RESPONSE TO REQUEST FOR ADDITIONAL INFORMATION

APR1400 Design Certification

RAI No.: 412-8525
SRP Section: 08.04 – Station Blackout
Application Section: 8.4
Date of RAI Issue: 02/22/2016

Question No. 08.04-14

Figure 1 Simplified Electrical Connection Diagram of the AAC GTG

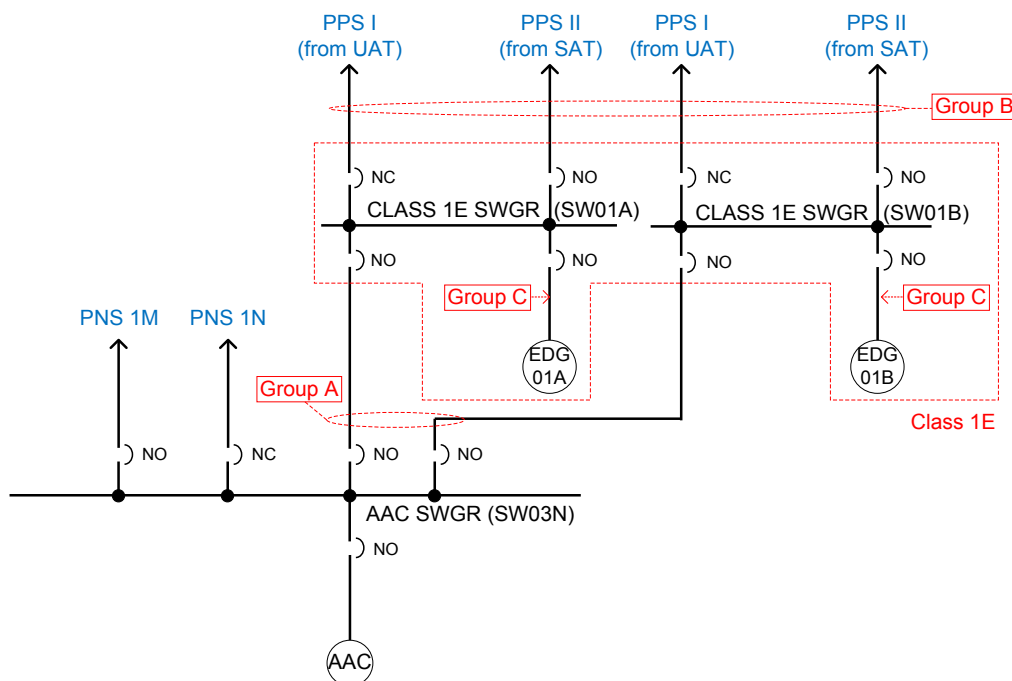
- a. Please provide a description of how the AAC power source is connected to the PPS.
- b. The applicant states: “The connections between the non-Class 1E AAC [switchgear] SWGR 3N and each Class 1E SWGR 1A and 1B are separated from the cables connecting the Class 1E SWGR 1A and 1B to the PPS as practicable such that impact on the connections of the AAC power source is minimized for events that affect the PPS.” Please provide the safety classification of cables connecting the AAC SWGR 3N to the Class 1E SWGR 1A and 1B, the Class 1E SWGR 1A and 1B to the PPS, and the Class 1E emergency diesel generators (EDGs) to the Class 1E SWGR 1A and 1B. Also, please discuss how the APR1400 design conforms to NRC RG 1.75 in regards to the separation of the cables.

- a. The alternate alternating current (AAC) gas turbine generator (GTG) is connected to the non-Class 1E 4.16 kV SWGR 3N (AAC SWGR 3N) through a normally open circuit breaker (CB). The AAC SWGR 3N is connected to each Class 1E 4.16 kV SWGR 1A and 1B through two normally open CBs in series. Since the AAC GTG is aligned to either the Class 1E switchgear 1A or 1B only in the event of a station blackout (SBO), there is no chance of connecting the AAC GTG to the preferred power supply (PPS). To illustrate the electrical connections among the AAC GTG, PNS SWGR, Class 1E SWGR, and PPS, a simplified diagram is provided, refer to Figure 1 below.
